Sent: 1/07/2018 6:52:37 PM
Subject: Objections to DA Mod2018/0294-DA0367/2010
Attachments: Mod2018-0294_DA0367-2010 submission by David Schmidt.pdf;

Re: SP 10040. Mod2018/0294-DA0367/2010

Figure 1: Drawing S96-202 SOUTH ELEVATION – Modified Application

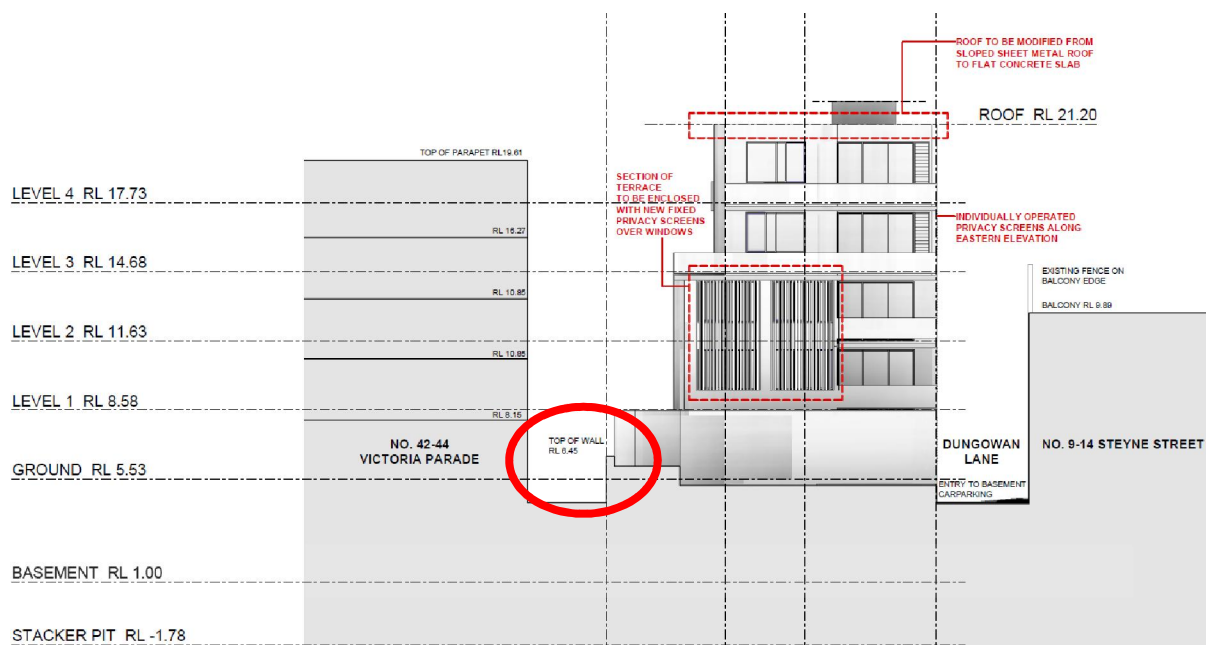
Top of Wall (circled red in Figure 1) along western boundary of the basement ramp is at an elevation of RL 6.45m in the modified DA, compared with RL 7.45m in the APPROVED DA and as deemed in Condition 97 of the 2012 LEC Consent (See Figure 4 (bottom)). This will potentially allow car headlights to shine directly into the lower units of the adjoining property 42-44 Victoria Pde (Units 1 and 5 especially). It appears this situation will be exacerbated by the new profile of the basement access ramp, revised to provide a 150mm freeboard from the edge of Dungowan Lane, for flood risk mitigation (Figure 2). The sight rise upon entry to the property off Dungowan Lane will cause headlight beams to project higher, allowing even more light to shine into the adjoining property.

driveway boundary fence to height of 7.45m to minimise head light glare on the adjoining property 42-44 Victoria Pde, pursuant to **Condition 97** of the 2012 LEC Consent **2.** Reduce roof height at its western edge to no higher than 20.2m and enforce the DA approved roof design, to reduce over-shadowing pursuant to **Condition 101** of the 2012 LEC Consent, **3.** maintain open construction of south-facing balconies of Floors 1 & 2 pursuant to 2012 LEC Consent **Condition 94**, and install obscure glass balustrades to a height of 1.6m on the western side of south-facing balconies at all levels, pursuant to **Condition 100** of the 2012 LEC Consent, and **4.** Ensure the shadow diagram has the correct existing DA APPROVED roof line, and revise as necessary and make results available to all interested parties.

Figure 3: Drawing No. DA30B – Court APPROVED Section A showing modification to height of roof and shadow lines of both modified and existing approved rooves, at times of 11am, 12pm and 1pm

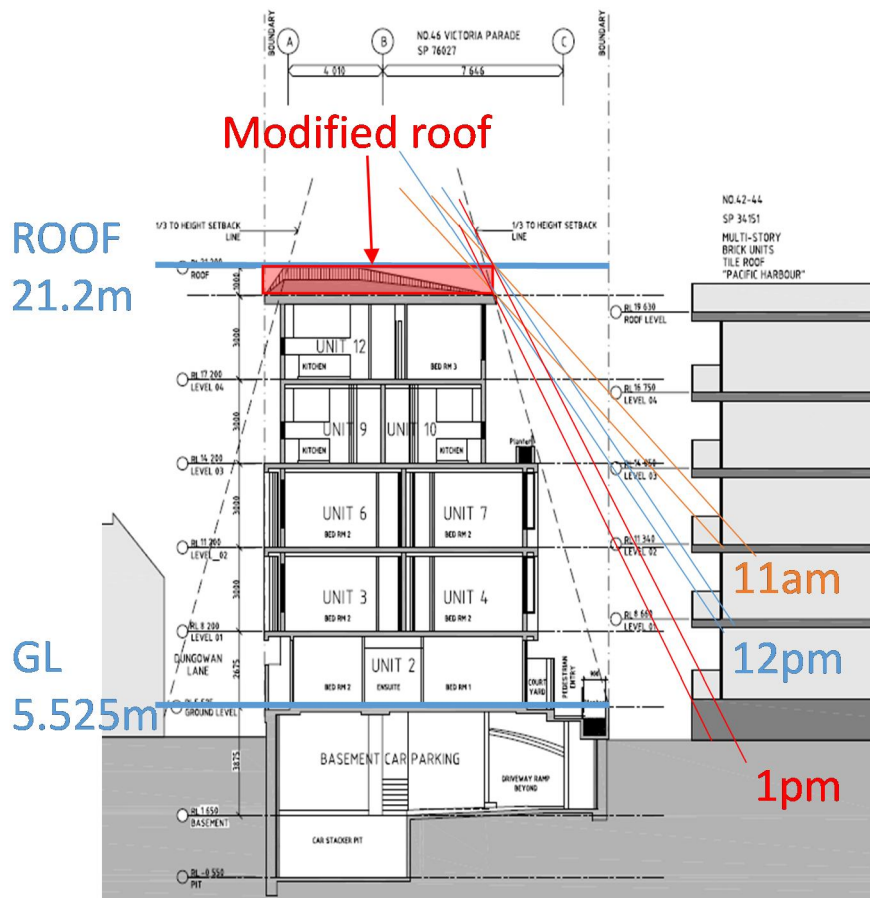
The diagram above (Figure 3) shows Cross-Section A of the existing approved DA (looking South with 42-44 Victoria Pde on right hand side), and the proposed roof modification. At the western edge of the roof (right-hand side), the elevation changes from RL 20.2m to RL 21.2m, an increase of 1m, as a result of the proposed flat roof. This has the effect of elevating the shadow line cast by the roof on the adjoining property 42-44 Victoria Pde by 1m. The three pairs of orange, blue and red straight lines depict the shadow cast by the roof, at times of 11am, 12pm and 1pm respectively (calibrated against the shadow diagram). The lower line represents the existing approved DA, and the upper line the modified DA. The vertical distance between the lines of each pair is about 1m, which is estimated to take about 20 minutes for the shadow line to traverse. In other words, the extension of the roof as proposed will delay the arrival of sun to the units overshadowed by the proposed DA by about 20 minutes, which represents about a 15% reduction in duration of time the sun shines on these units, in mid-winter. This will affect Units 1 & 5 especially, and pathways along the eastern side of the building which may become damp and slippery because of reduced sunlight.

Figure 6: Shadow diagrams (a) dated 17 March 2014, (b) dated 30 June 2014, (c) dated 2018

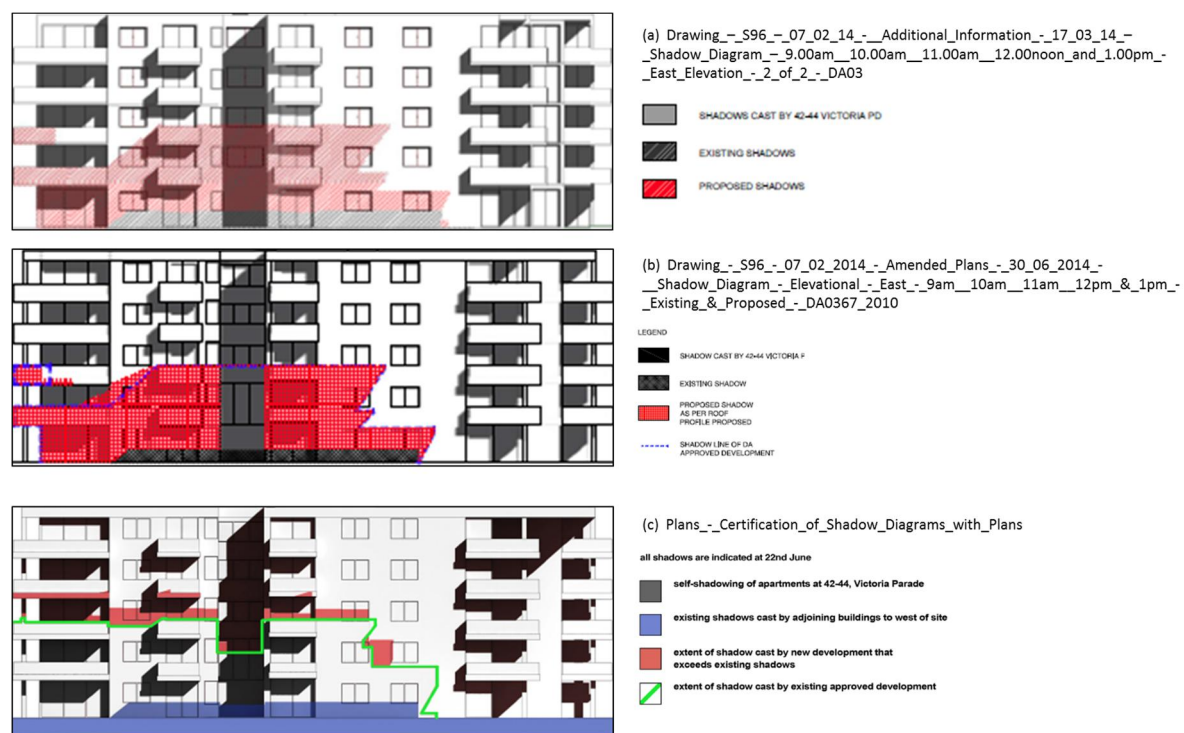
The figure below (Figure 6) shows shadow diagrams taken from Council's website, dated as indicated in the figure caption. The time of the shadow model is 11am in mid-Winter. The shadow line of the DA APPROVED development is indicated by the blue outline of Figure 6(b), dated June 2014. It appears to be very similar to but not exactly the same as, the outline of the red area in the diagram above (Figure 6(a)), dated March 2014. The extent of the blue shadow outline was amended in Figure 6(b) presumably after March 2014 and before June 2014, to account for a "proposed roof profile", details of which are unknown to this author. This amendment is indicated by the red shaded area in Figure 6(b). Neither the amended area nor the blue outline of the DA approved development match in detail the green outline shown in Figure 6(c), which is claimed in the MODIFIED DA to be the existing APPROVED DA (and therefore should be the same as the blue outline). The biggest differences (those of concern) occur at the left hand side of the diagram, in the vicinity of Units 9, 5 and 1 on levels 2, 1 and Ground respectively.

The DA approved shadow line would be influenced by the "notch" in the western roof line (see Figure 7), and thus shows a dip downwards below the balcony of Unit 9 on Level 2. The straight profile of the green outline appears to have ignored this "notch".

A flat roof at 21.2m as proposed in the MODIFIED DA would project a shadow as indicated by the red area Figure 6(c). The figure seems to suggest that the modified roof would not add much to the DA APPROVED shadow line, but that may not be the case in the vicinity of Units 1, 5 & 9 especially, where the impact could be far greater than indicated, with Unit 5 & 9 balconies having no sunshine at 11am with the MODIFIED DA, whereas they do have sunshine with the APPROVED DA.
